Field Notice

Hysterolux™ Fluid Management System Control Unit- REF 72205000

WOM reference no.: 2021-0002

Figure 1 Pump Control Unit display showing the calculated deficit (Deficit display) and inflow volume count (Total Inflow volume display). The latter will freeze, once 32,450 ml has been reached.

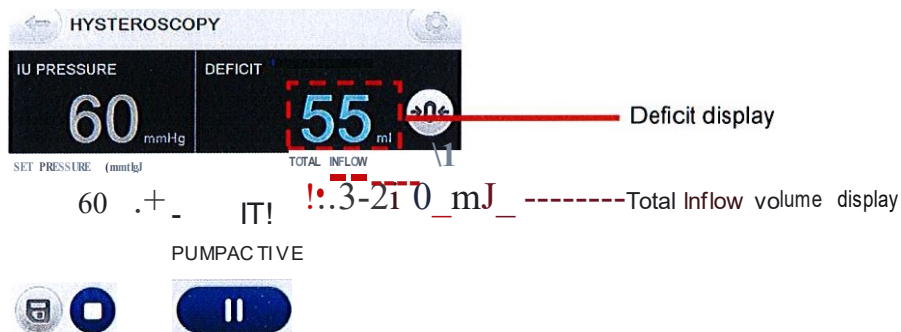
This field notification is being issued following reports from customers from the USA that the display of inflow volume on the Hysterolux™ Fluid Management System can reach its limit of 32,450 ml during long procedures. In these cases, the display does not indicate the actual inflow volume. In cases where an unusually high amount of fluid is used for distension of the patient's uterus, the calculation of the inflow and outflow volumes reaches its limit and the Control Unit display will freeze at the maximum value.

Our investigation has identified a software anomaly as the cause for this display freeze. The reason for this is that at 32,450 ml an internal software calculation threshold is being reached. As the outflow measurement will continue, the result is that the deficit accumulated up to this point will start counting backwards until 0 ml is reached.

This incorrect display of fluid inflow can result in fluid overload. Fluid overload can be affected by distension pressure, flow rate and duration of the hysteroscopic surgery. It is critical to closely monitor the inflow and outflow of the distending fluids at all times. The pressure should be kept as low as possible to allow for a sufficient intrauterine distension and to reduce the forces that could allow fluid, ambient air, and/or gas into the circulatory system.

W.O.M. WORLD OF MEDICINE GmbH has developed a software version, which, when an inflow volume of 28.000 ml is reached, alerts the user that the limit is being approached and is designed to prepare the user for a manual determination of the deficit.

The new software version is implemented during the next preventive maintenance of your Hysterolux™ Fluid Management System Control Unit. If you wish to update the software of your device at an earlier date, please contact your sales representative of Medtronic Inc., who will assist in returning the unit and providing an exchange unit.
